**Board of Zoning Appeals  
Kiawah Island Municipal Center  
July 15, 2024; 1:00PM**

**Case #BZA24-000010**  
**Kiawah Island BZA Meeting of July 15, 2024**

**Case #BZA24-000011**  
**Kiawah Island BZA Meeting of July 15, 2024**

### Front Yard Setback Encroachment

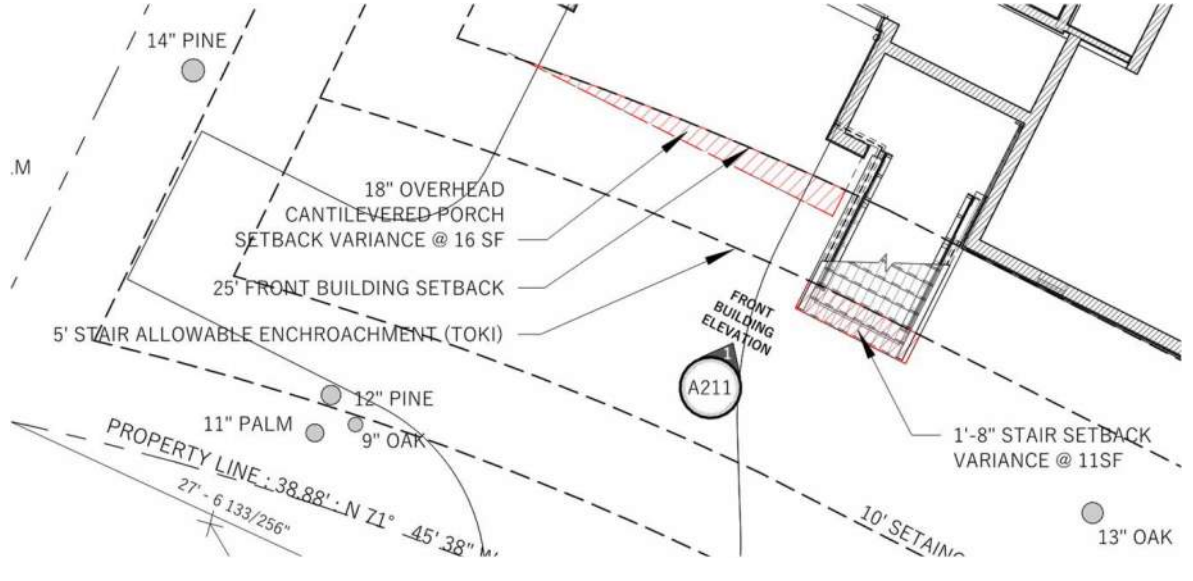
The applicant's proposed plans include a new single-family residence. The applicant's proposed plans include a staircase and porch that encroaches into the required 25' front setback. The applicants proposed plans include uncovered stairs which extend into the required 25' front setback by approximately 6 feet 8 inches, which exceeds the 5-foot administrative relief by approximately 1 foot 8 inches. The total encroachment of the stairs is approximately 11 square feet. The proposed covered porch extends into the required 25' front setback by approximately 1 foot 6 inches. The total encroachment for the porch is approximately 16 square feet.

### Side Yard Setback Encroachment

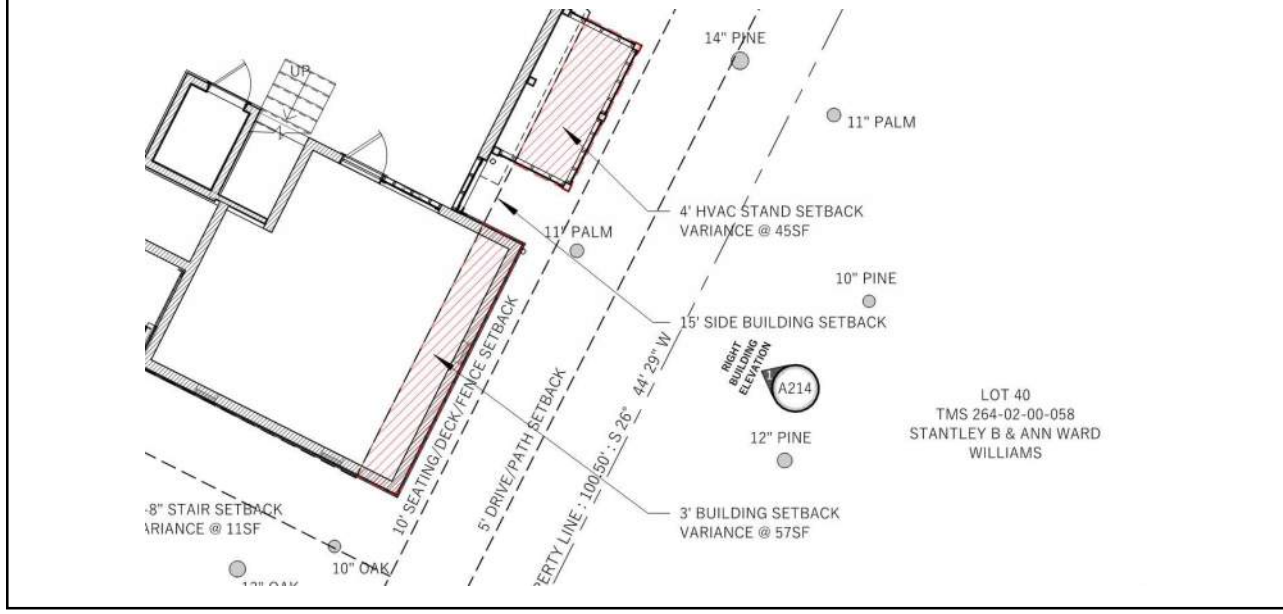
The applicant's proposed plans include a 3 foot encroachment into the required 15' side setback to the east for the proposed single family residence in addition to a 4 foot

### Rear Yard Setback Encroachment

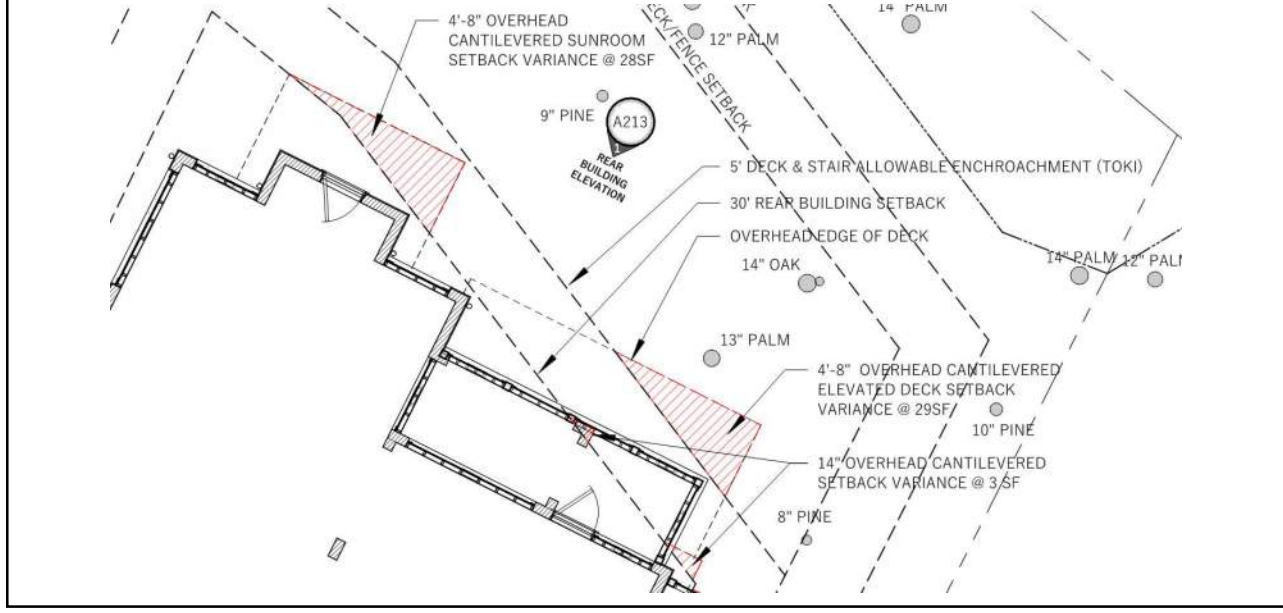
The applicant’s plans include an uncovered deck which encroaches into the required 30’ rear OCRM Critical line setback by approximately 9 feet 8 inches. The proposed deck extends approximately 4 feet 8 inches beyond the five feet administrative relief. Additionally, the applicants proposed plans include 3 separate cantilevered structures extending at a maximum of 4 feet 8 inches into the required 30’ rear OCRM Critical Line setback. The footprint of the proposed rear deck sits approximately 20 feet feet from the OCRM Critical Line at its closest point.

### Proposed Site Plan

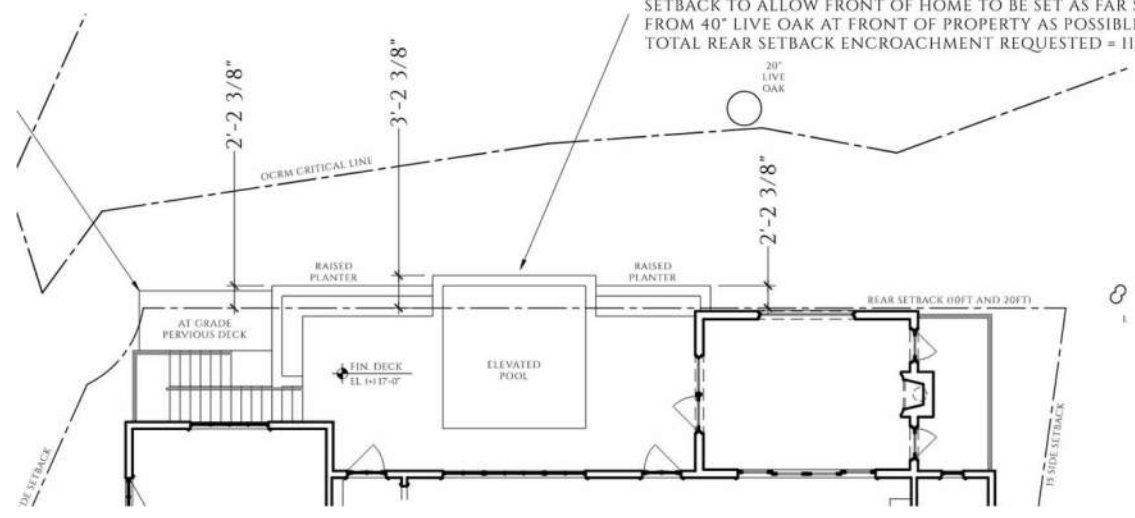
The applicant's proposed plans include a pool and raised planters located in the rear of the property. The proposed raised planters encroach into the required rear setback by approximately 2 feet 2 inches and is raised approximately 8 feet 6 inches above slab

grade. The raised pool located between the two raised planters encroaches into the rear setback by approximately 3 feet 2 inches and is approximately 10 feet above slab grade.

VARIANCE REQUESTED TO ALLOW ELEVATED POOL (EL. 17'-0") AND (2) RAISED PLANTERS (EL. 15'-6") TO ENCROACH OVER REAR SETBACK TO ALLOW FRONT OF HOME TO BE SET AS FAR SOUTH FROM 40" LIVE OAK AT FRONT OF PROPERTY AS POSSIBLE. TOTAL REAR SETBACK ENCROACHMENT REQUESTED = 110SF.
